# UNITED STATES PATENT AND TRADEMARK OFFICE

APPLICATION NO.	FILING DATE	FIRST NAMED INVENTOR	ATTORNEY DOCKET NO.	CONFIRMATION NO.
10/754,394	01/09/2004	Michael Frank Walsh	WMFR-P01-001	9186

<b>Office Action Summary</b>	<b>Application No.</b> 10/754,394	<b>Applicant(s)</b> WALSH, MICHAEL FRANK	
	<b>Examiner</b> Ernesto Garcia	<b>Art Unit</b> 3679

### **DETAILED ACTION**

FIG. 2.

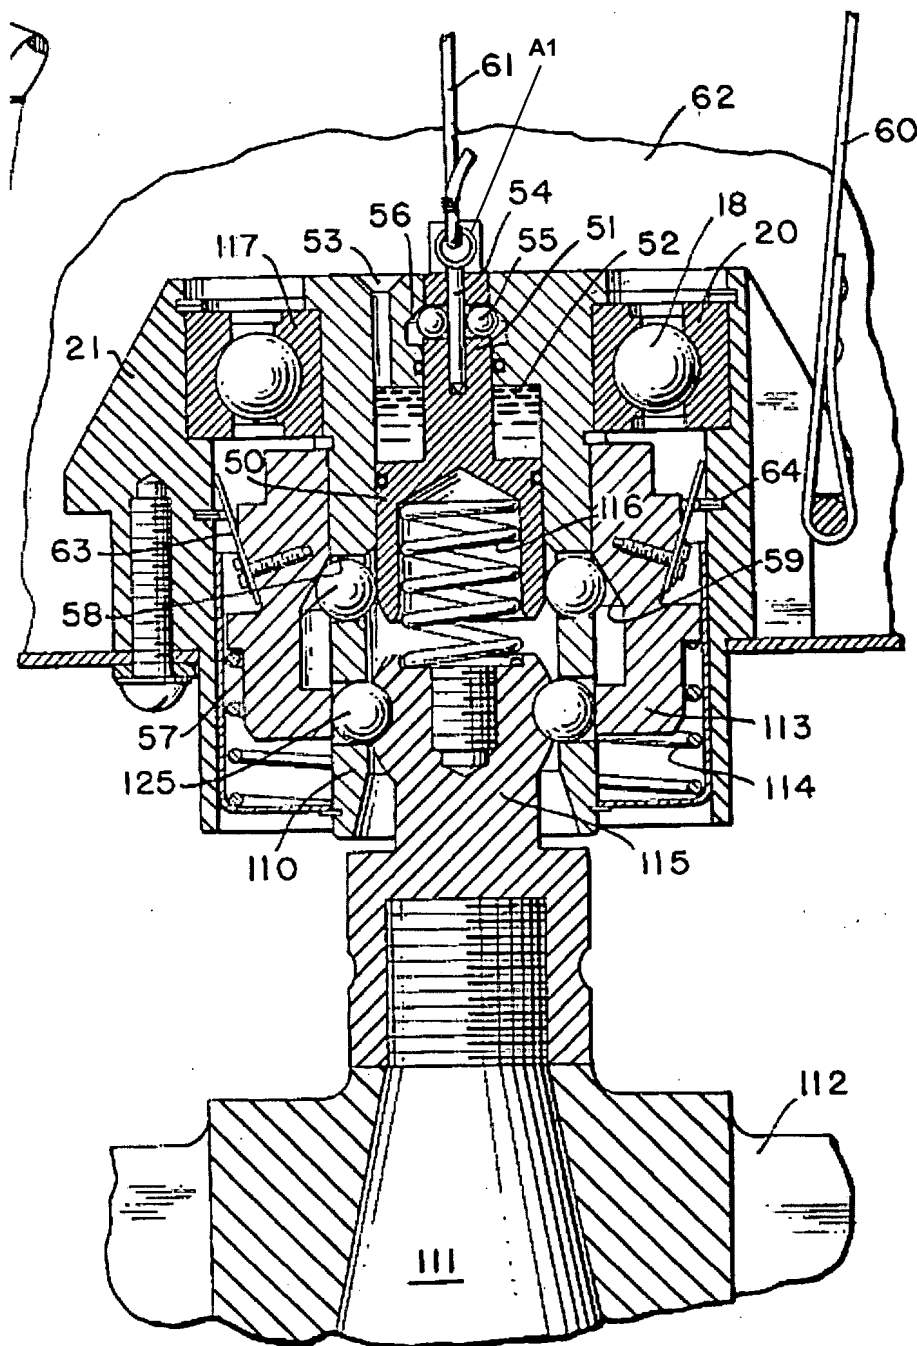
Regarding claim 1, Bemis discloses, in Figure 2, a low-force release mechanism comprising a main structure **110**, a trap **113**, an internal spring pin **51** with an internal spring **116**, a release pin **54**, a least one trigger **A1** (see marked-up attachment), one or more ball bearings **57**, and attachments **125** by which a container **T** is attached to the main structure **110** and the trap **113**. The release pin **54** is configured to be moveable to effect a position of the one or more ball bearings **57** located in the main structure **110** and within an internal geometry of the trap **113**. A load force is distributed to the main structure **110** and to the trap **113** away from the release pin **54**. The one or more ball bearings **57** interact with the internal geometry of the trap **113**. The position of the trap **113** is locked and held. The one or more ball bearings **57** retract upon removal of the release pin such that application of a low force on the trigger **A1** causes the internal spring pin **51** and the release pin **54** to move a position of the container.

Regarding claim 9, Bemis discloses, in Figure 2, a low-force release mechanism comprising a main structure **110**, a trap **113**, an internal spring pin **51** with an internal spring **116**, a release pin **54**, a least one trigger **A1** (see marked-up attachment), one or more ball bearings **57**, attachments **125** by which a container **T** is attached to the main

Regarding claim 11, Bemis discloses, in Figure 2, a low-force release mechanism comprising a main structure **110**, a trap **113**, an internal spring pin **51** with an internal spring **116**, a release pin **54**, a least one trigger **A1** (see marked-up attachment), one or more ball bearings **57**, attachments **125** by which a container **T** is attached to the main structure **110** and the trap **113**, and a trap spring **114**. The release pin **54** is configured to be moveable to effect a position of the one or more ball bearings **57** located in the main structure **110** and within an internal geometry of the trap **113**. A load force is distributed to the main structure **110** and to the trap **113** away from the release pin **54**. The one or more ball bearings **57** interact with the internal geometry of the trap **113**. The position of the trap **113** is locked and held. The trap spring **114** and the ball bearings **57** interact with the geometry of the trap **110**. The one or more ball bearings **57** retract upon removal of the release pin such that application of a low force
